Rear Cap Bracket and Fuel Filter Housing

Bulletin Type:	Recall	Publication Date:	May 2025
Bulletin #(s):	25V-241	Make(s):	Entegra Coach
Job Code(s):	9903625	Model(s):	Aspire (44D, 44R, 44C) Anthem (44D, 44V) Cornerstone (45B, 45D, 45V)
Flat Rate(s):	9903625 .50 HR Rear Cap Bracket Repair		Model Year(s):

Incident:	Rear cap bracket making contact with fuel filter housing.
Affected Units:	2025 - 2026 Entegra Coach Aspire, Anthem, Cornerstone
Parts Kit:25V-241	Parts Kit #: 25V-241
	Part Kit Contents: 1 EA – PLATE,RR CAP SPRT 04.00X06.00 10GA BPC 3 EA –SCREW,HEX WSHR .25X1.00 TEK3 ZC 3 EA – WASHER,FL .25 ZC USS
Misc. Tools & Supplies:	Screw Gun with ¼” Hex Head Driver Bit
Parts Return Information:	N/A

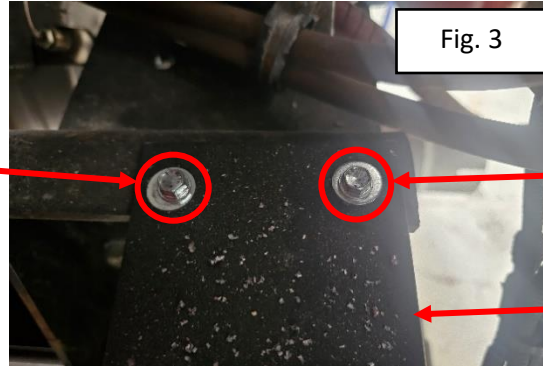
- Using a screw gun and ¼” hex head driver bit, remove the fastener holding the bracket to the chassis frame. (Figure 1)

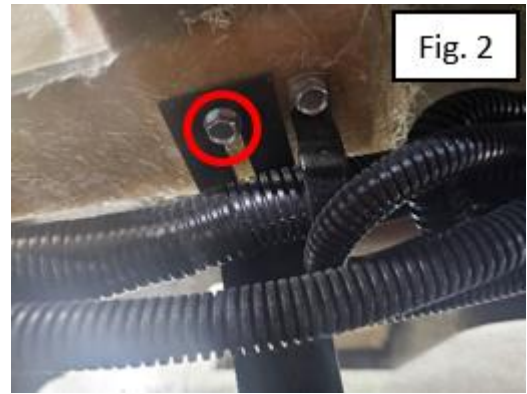
2. Loosen the second fastener between the bracket and the rear cap. (Figure 2)
 - a. **Note: You will only want to loosen this fastener and not fully remove it.**
3. With the bracket loosened, move it over and out of the way.
4. Use two fasteners and two washers to secure the new plate to the chassis frame where the bracket was originally secured. (Figure 3)

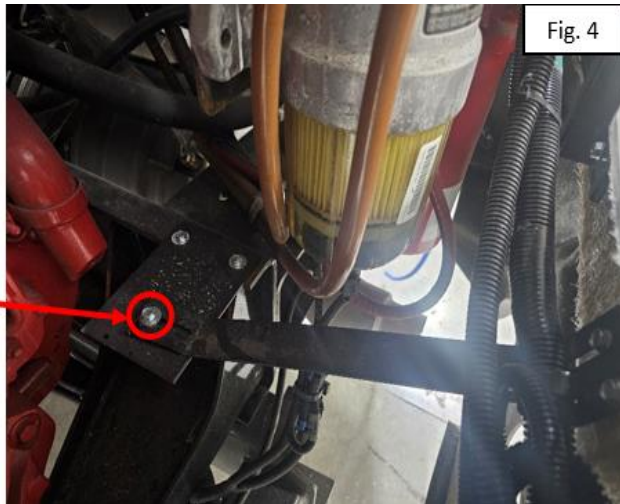
5. Swing the bracket back down and into position over the plate. Then use one fastener and one washer to secure the bracket to the plate. (Figure 4)
6. Re-fasten the screw that was loosened between the bracket and the rear cap. (Figure 5)
